PROJECT : HONOAPIILANI HIGHWAY
Kahana to Alaeloa

PROJECT NO.: F-030-1(13)

DRAINAGE

STATE OF HAWAII
DEPARTMENT OF TRANSPORTATION
LAND TRANSPORTATION FACILITIES DIVISION
DRAINAGE & IRRIGATION PLAN
HONOAPIILANI HIGHWAY
Kahana to Aiealoa
F.A. Proj. No. F-030-1(13)

SHEET No. 120HAOF 31 SHEETS

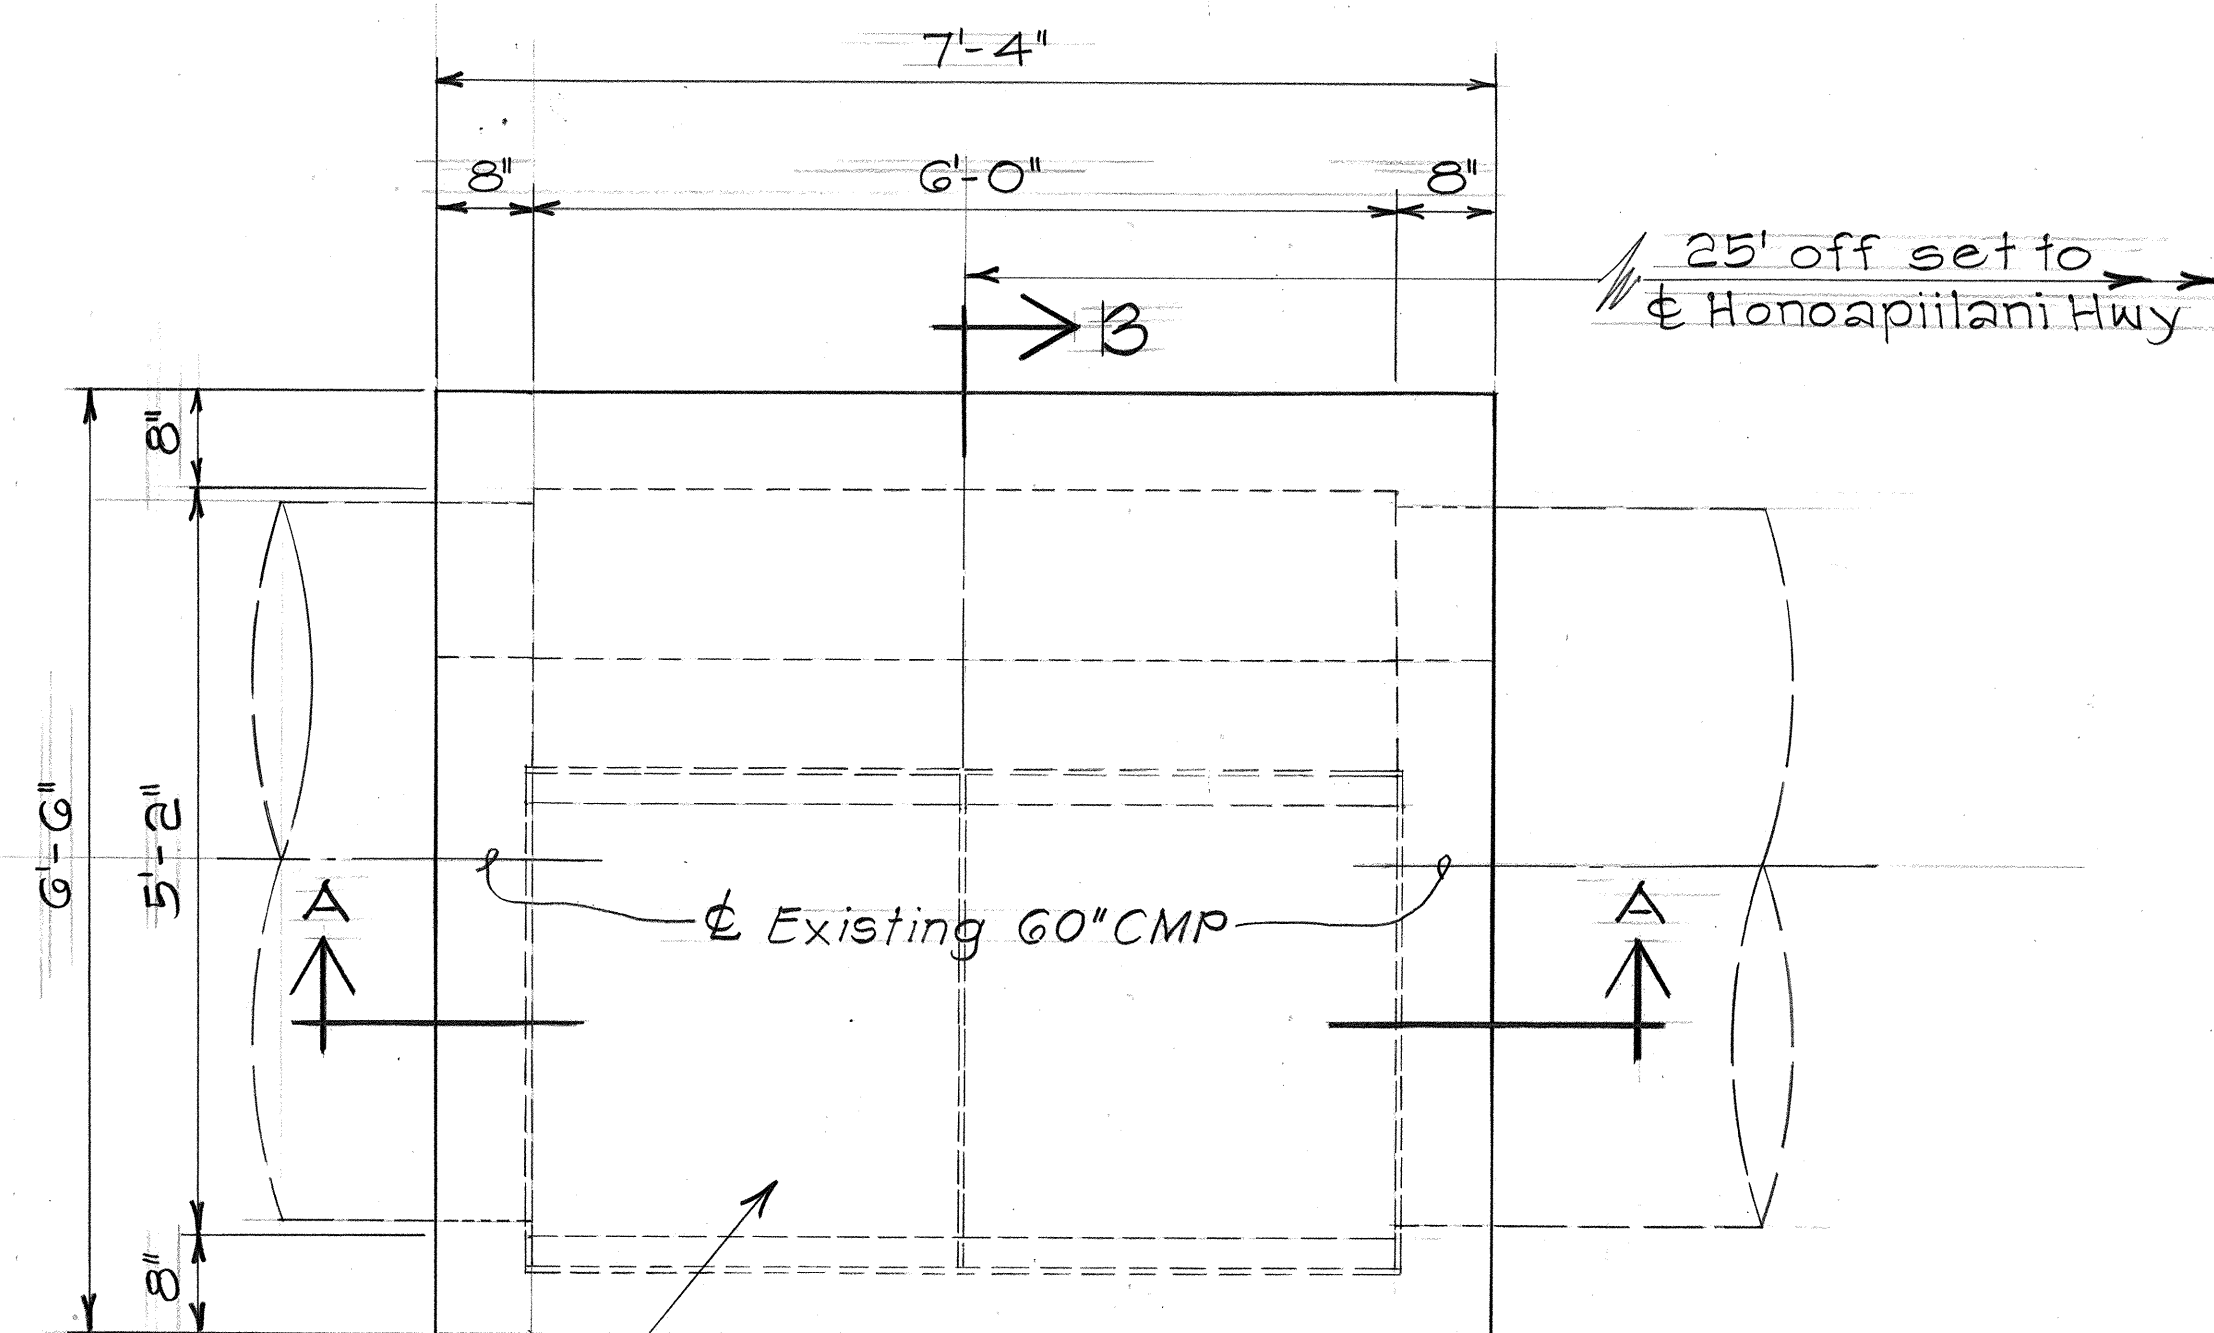
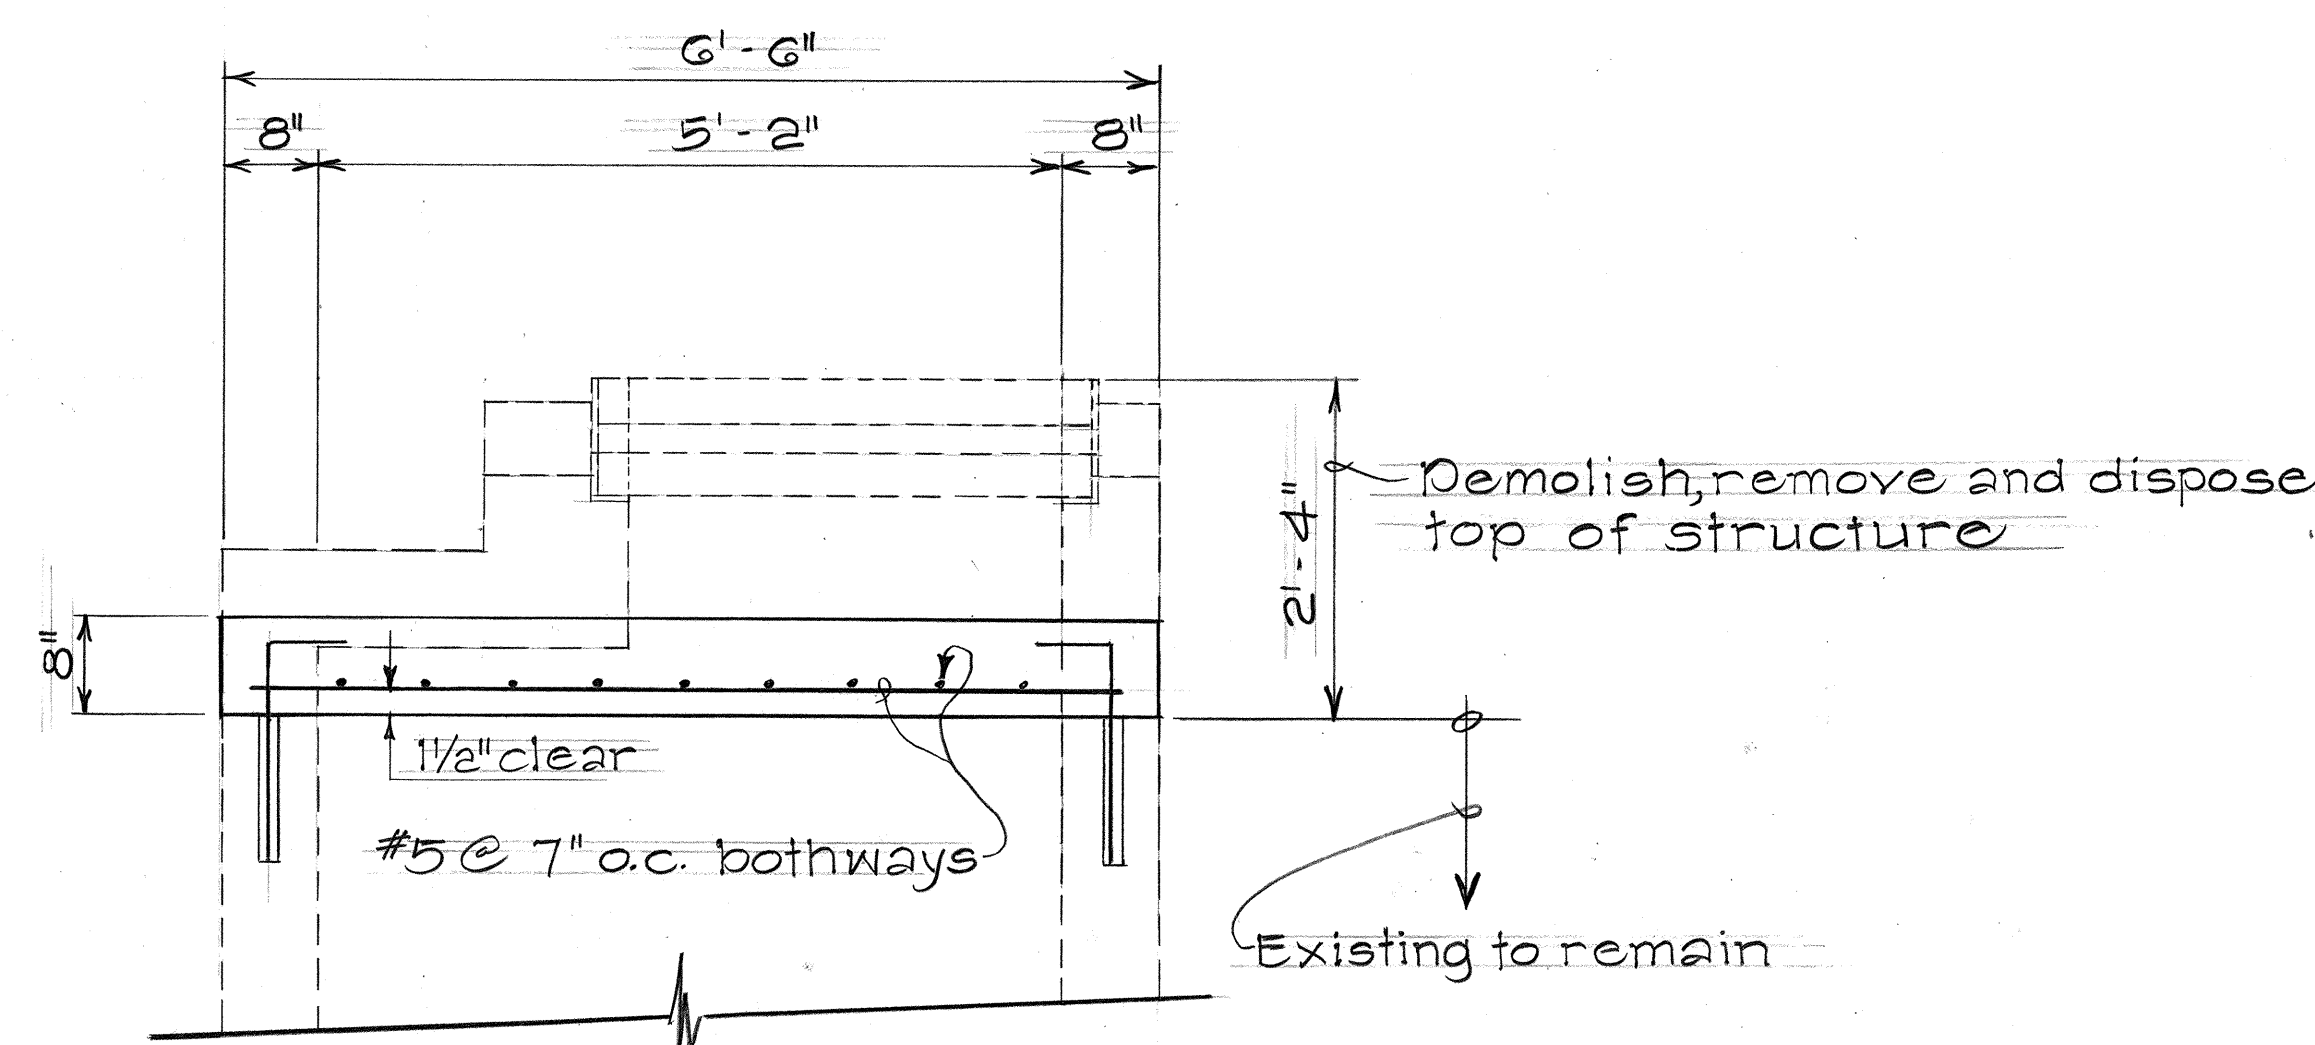
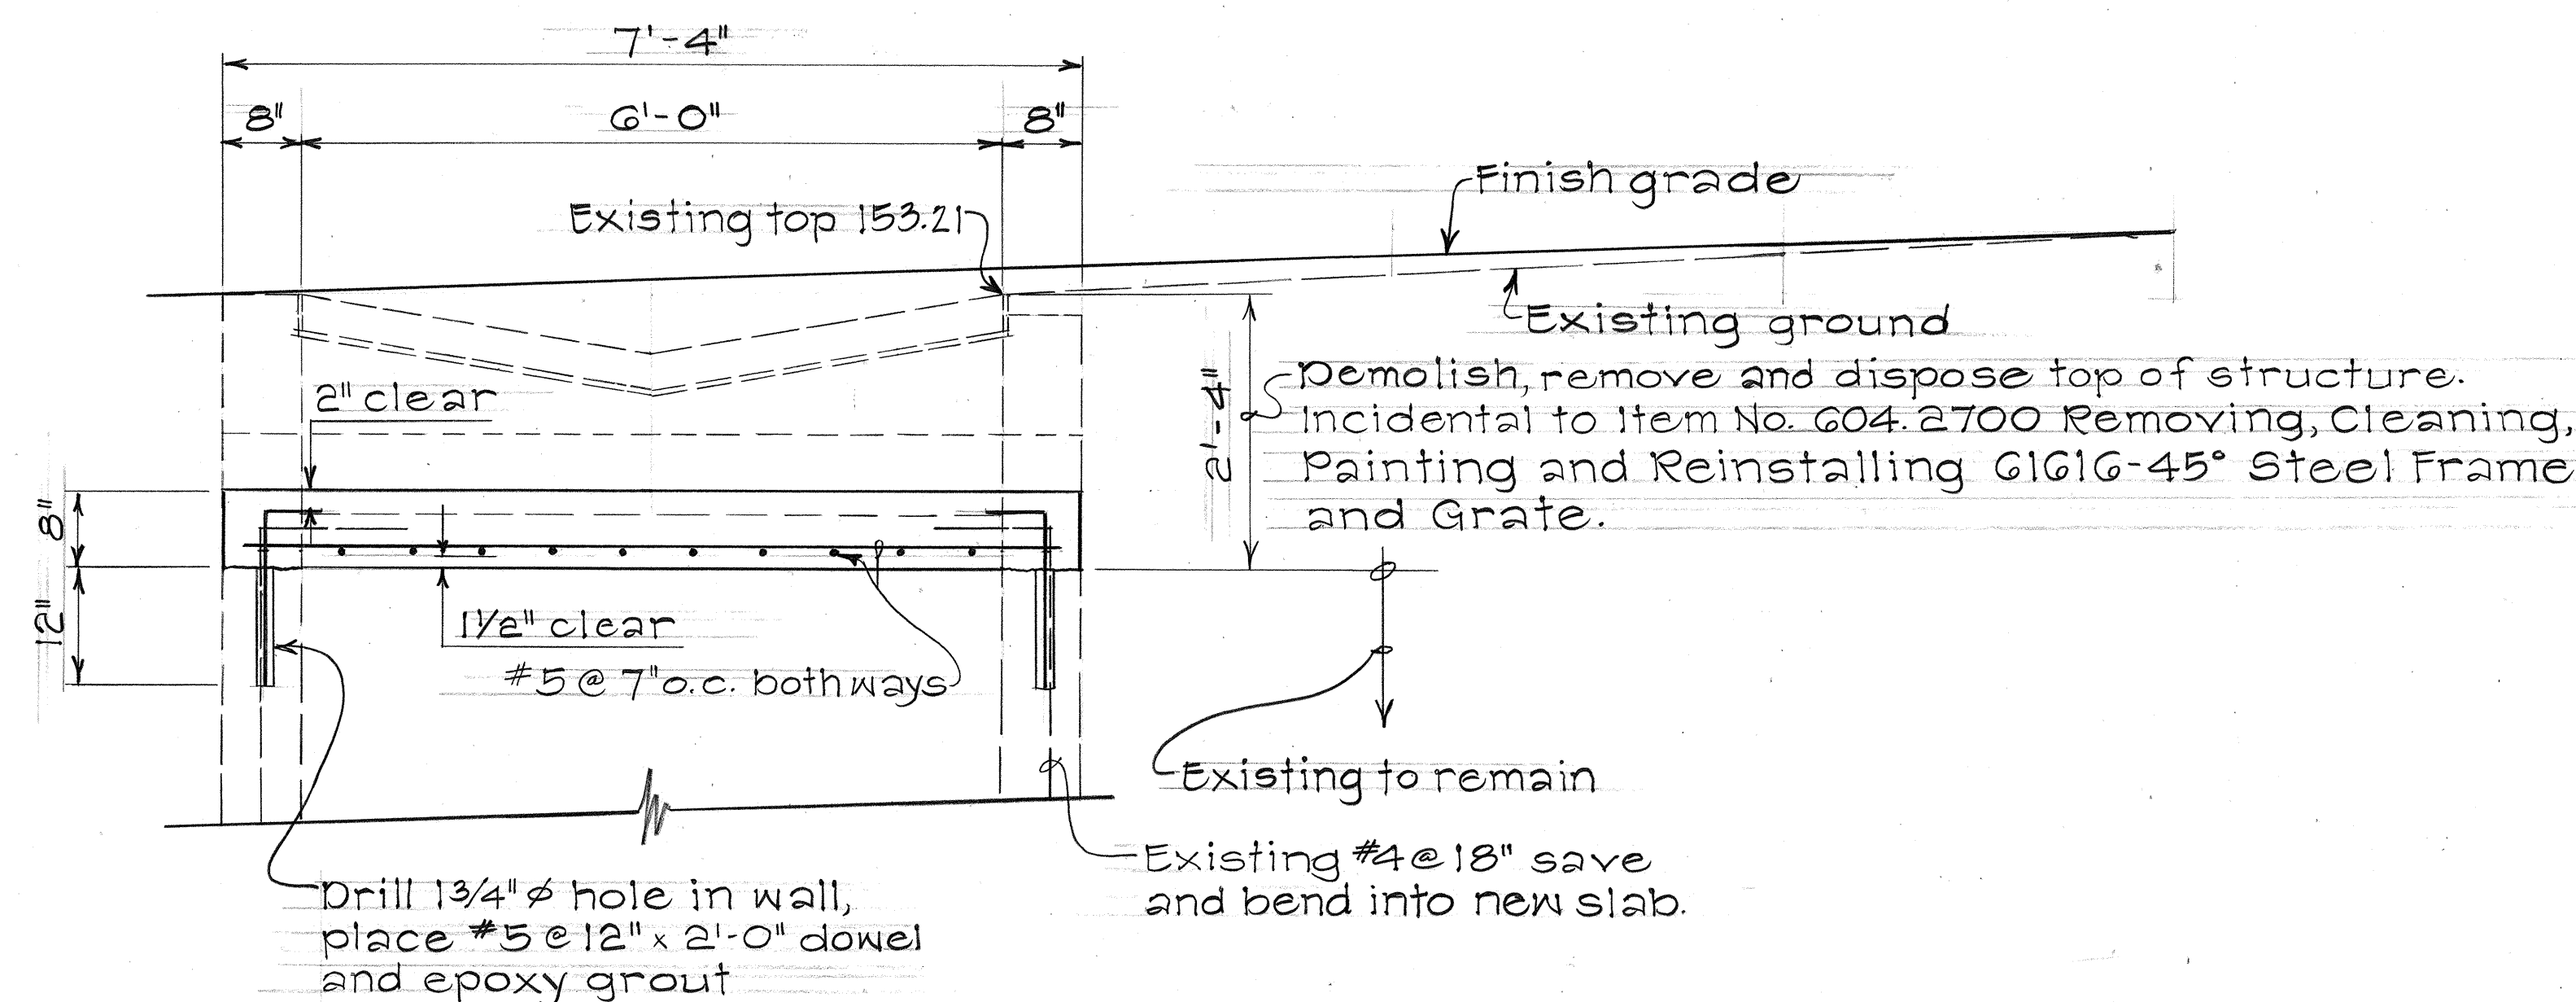
17 Sep 79 Tracing added to show details of drainage structures for new roadway intersection.
